RESPONSE TO REQUEST FOR REVIEW

Reference: Request for review - 0830 Rialma Companhia Energética I S/A. - Santa Edwiges I Small Hydro Power Plant - Small Scale CDM Project , sent in e-mail of 20/08/2010 07:26

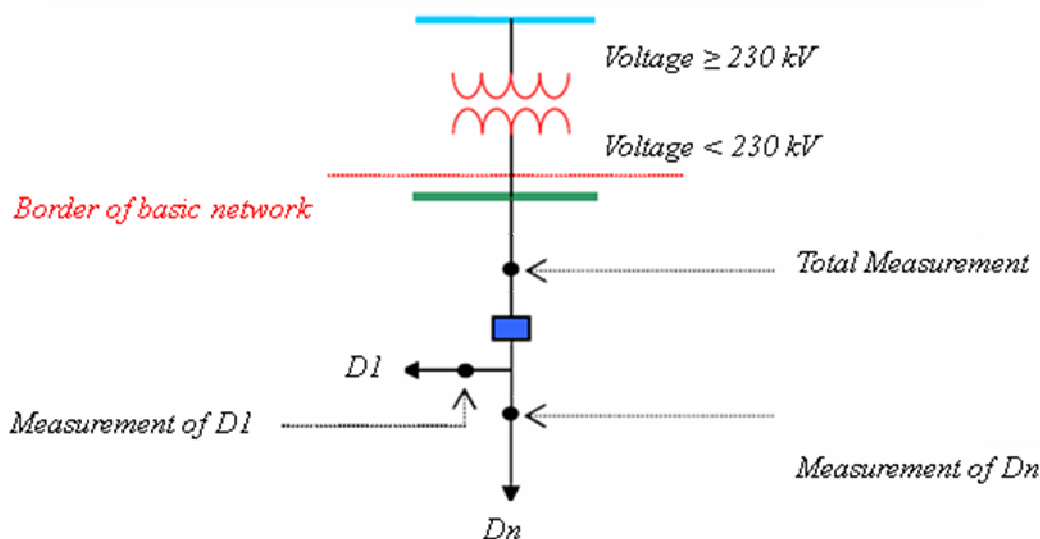
The DOE shall clarify how it confirmed that:

(1) The monitoring of electricity supplied to the grid from the project activity was conducted in accordance with the monitoring plan considering that the monitoring plan has not specified connection of other hydro plants (Santa Edwiges II and III) to the meters.

(2) There has not been any change in the monitoring system since last verification, considering that the last verification report mentioned that the meters at the substation measured electricity delivered to the grid by the project activity whereas the current verification report mentions that the meters located at the substation measured electricity delivered to the grid by three hydropower plants: Santa Edwiges I, II and III.

As detailed in the current verification report, the monitoring system of Santa Edwiges I is based on a configuration of measurement points that considers the individual readings of electricity generated by each one of the three hydropower plants, Santa Edwiges I, II and III, in addition to the measurement of their total generation, at the border of transformation, downstream of the plants' individual energy meters.

Such configuration is approved by ONS – the Brazilian National Power System Operator¹ –, in accordance to its grid procedures, “Sub module 12.2: Installation of the Measurement System for Invoicing (Rev. 01)”, “Section 6: Location of Measurement Points”, in paragraph 6.5:

The individual hydropower plants' energy meters readings (measurement points *D1*, *D2* and *D3*, controlled by CCEE – The Brazilian Chamber of Electrical Energy Commercialization –, upstream of Alvorada do Norte's substation, the one the project activity is delivering the generated electricity into, and compliant with the national grid procedures, leads to reliable measurement and determination of electricity generation by the project activity.

As mentioned in the last verification report, the meters of the substation – referring to Alvorada do Norte's – measure electricity delivered to the grid by the project activity, since such measurement point is located at the border of transformation, the point where net energy is actually being delivered. At this point, losses due to transmission lines – that connect the project activity's generating units to the substation – and the electricity generated by the other two plants have already

During current verification, the DOE’s team verified that CCEE’s CB002 report presents official data on the “electricity generation of the project activity delivered to grid” which is 1.6% lower, in average, than the data monitored by the “project owner (seller)”. Thus, confirming that the transmission losses and the electricity generated by the other two plants have been duly discounted.

As per the registered PDD’s approved monitoring plan, the only electricity production to be monitored is the “Electricity generation of the Project delivered to grid” – which occurs at Alvorada do Norte’s substation –, independently of the configuration (e.g. “connection of other hydro plants”) upstream of such measurement point.

Therefore, the DOE confirms that monitoring of electricity supplied to the grid from the project activity was conducted in accordance with the monitoring plan.

So, as presented above, there has been no change in the monitoring system neither in the verification process since the last verification or in the monitoring plan. The difference verified between the current verification report and the previous ones (more detailed information on the monitoring system) is a result of the application of the *Guidelines on Completeness Check of Requests for Issuance* (EB 48 Annex 68), issued after the date of the last verification report (28/04/2009) and before the date of the current one (23/03/2010). Based on the requirements of Clause 10, of the guidelines, a more detailed monitoring report was presented by the PPs, which as a consequence lead to a more detailed verification report.
